**[Docket No. FAA–2023–0670; Project Identifier AD–2022–01427–T]**

**Airworthiness Directives; The Boeing Company Airplanes**

**ACTION:** Notice of proposed rulemaking (NPRM).

Figure 1 to paragraph (g)(2)(i)—*Fundamental Effective Isotropic PSD at Outside Interface of Aircraft Antenna*

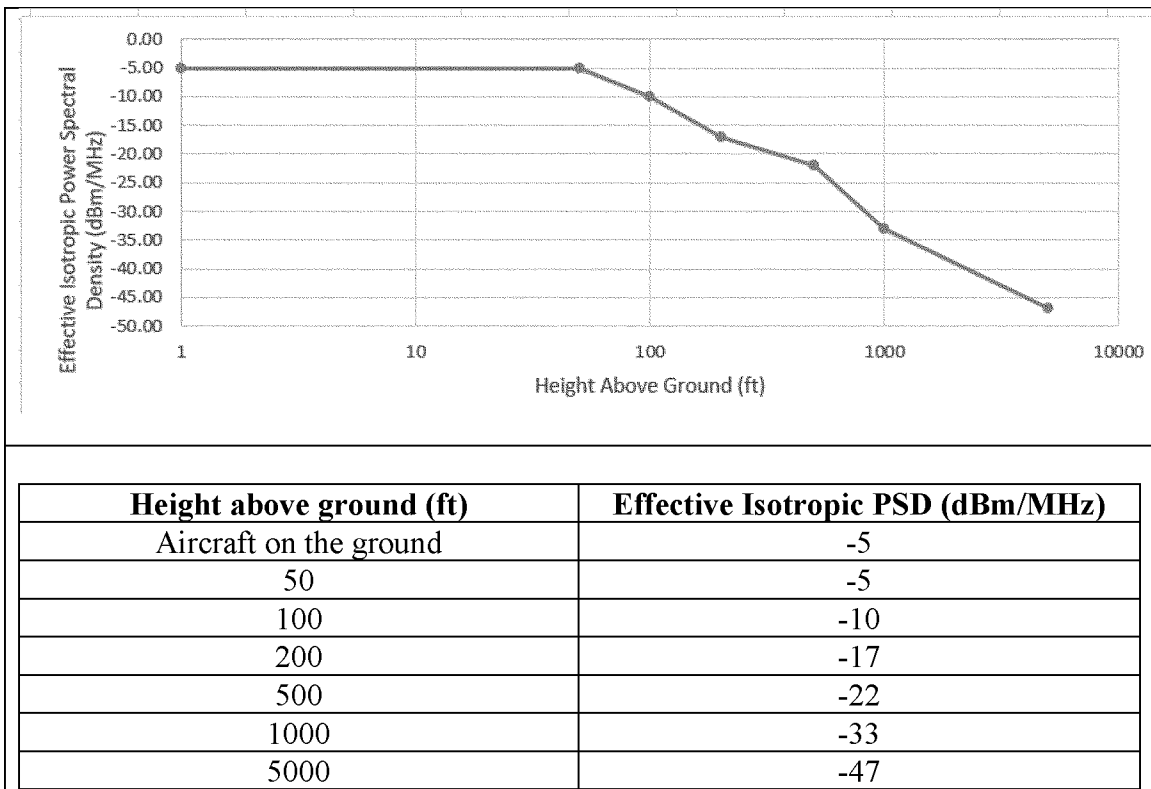
(i) Tolerance to radio altimeter interference, for the fundamental emissions (3.7–3.98 GHz), at or above the power spectral density (PSD) curve threshold specified in figure 1 to paragraph (g)(2)(i) of this AD.

Figure 2 to paragraph (g)(2)(ii)—*Spurious Effective Isotropic PSD at Outside Interface of Aircraft Antenna*

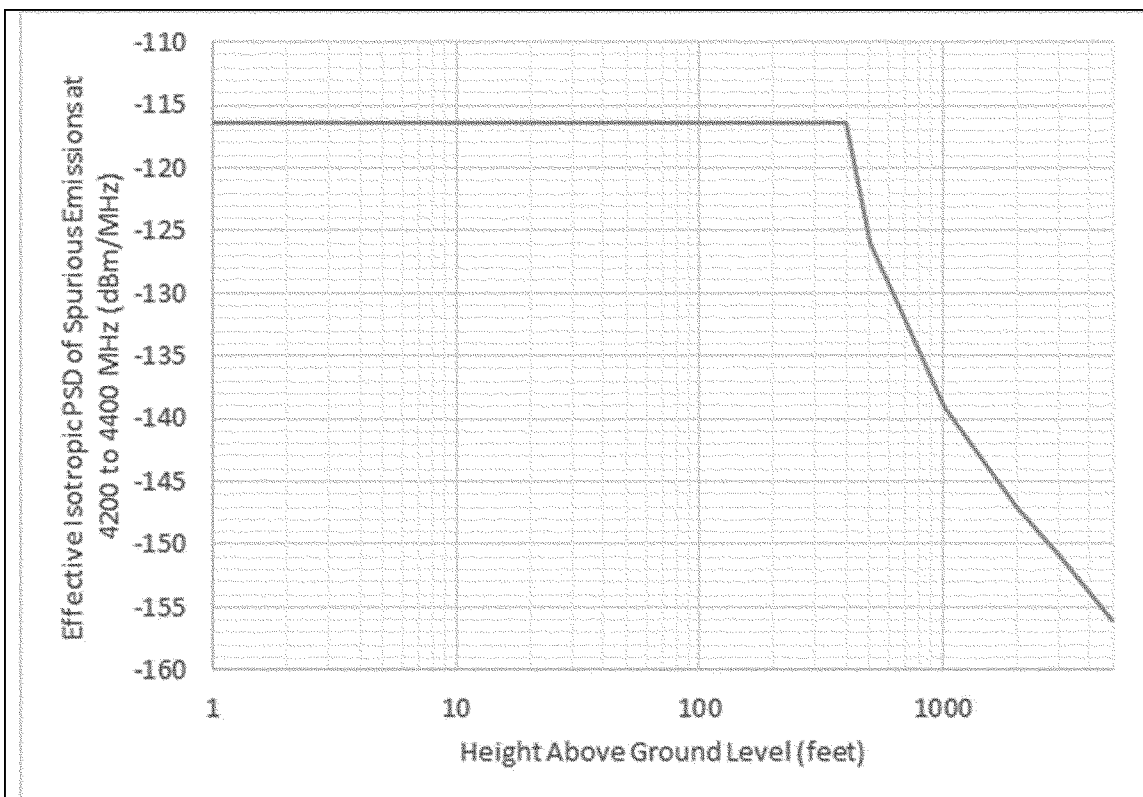
(ii) Tolerance to radio altimeter interference, for the spurious emissions (4.2–4.4 GHz), at or above the PSD curve threshold

specified in figure 2 to paragraph (g)(2)(ii) of this AD.
